# Work Order ID 95956

Item Name: 205 Bent Tube

DRAWING NO. D2580	TITLE 205 SKIDTUBE ASSEMBLY	REV. E	<b>DART AEROSPACE LTD ENGINEERING ORDER</b>	D.E.O. NO. D2580-E-1.	SHEET NO. SHEET 1 OF 1	SCALE NTS
DRAWN <i>JP</i>	CHECKED <i>ASS</i>	MFG. APPR. <i>EC</i>	APPROVED <i>[Signature]</i>	DE APPR. <i>[Signature]</i>		
DATE 11.12.13	DATE 11.12.13	DATE 11.12.13	DATE 11.12.13	DATE 11.12.13

CHANGE ALL C'BORED WELDED CROSSBOLT SPACERS TO SWAGED SPACERS

**SECTION B-B, F-F, I-I**  
NOT TO SCALE

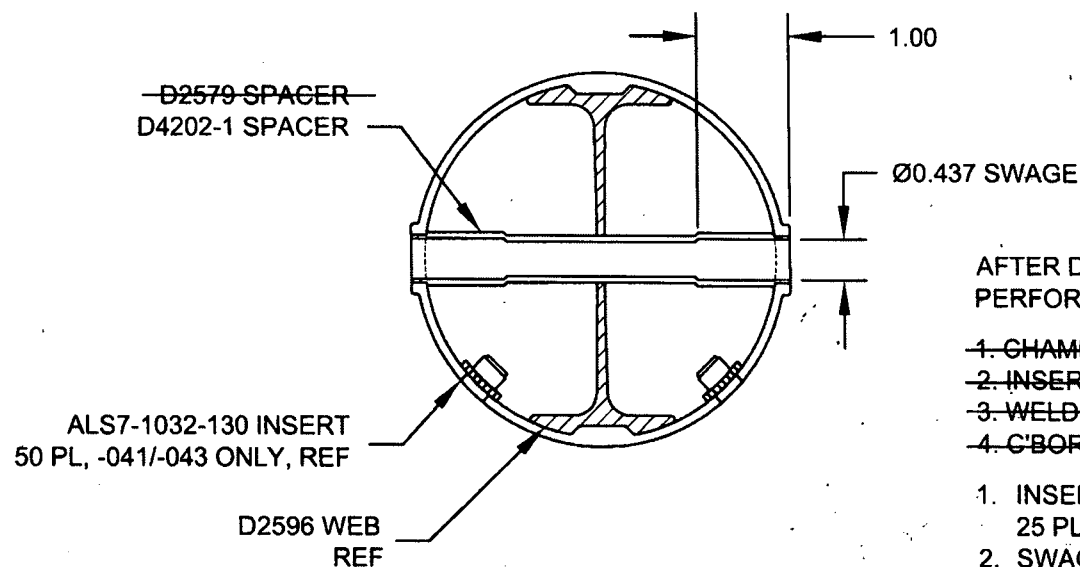
PARTS LIST IS AMENDED AS FOLLOWS:

WAS

QTY	QTY	QTY	PART NUMBER	DESCRIPTION
-041	-045	-047		
20	24	25	D2579	CROSS BOLT SPACER

IS

4		* D2579	CROSS BOLT SPACER
20	20	25	D4202-1	SPACER

SECTION B-B, SECTION F-F, & SECTION I-I ARE AMENDED AS FOLLOWS  
FOR ALL HOLES THAT WERE ORIGINALLY C'BORED:

**\* FOR -045 SKIDTUBE ONLY:**

WELD 4X D2579 SPACERS PER DWG  
IN LOCATIONS MARKED "NO C'BORE".  
REF SHEET 4 OF DWG.

AFTER DRILLING AND BENDING ASSEMBLY  
PERFORM THE FOLLOWING FOR Ø0.508 HOLES ONLY:

1. CHAMFER HOLE 0.060 X 45°
2. INSERT D2579 SPACER (20 PLACES)
3. WELD INTO PLACE AND GRIND FLUSH
4. C'BORE D2579 SPACER TO Ø0.437 X 1.00 DEEP

1. INSERT D4202-1 SPACER, 20 PL (-041) OR 20 PL (-045) OR 25 PL (-047)
2. SWAGE TO Ø0.437 X 1.00 DEEP PER QSI 002
3. TRIM / GRIND FLUSH PER QSI 002
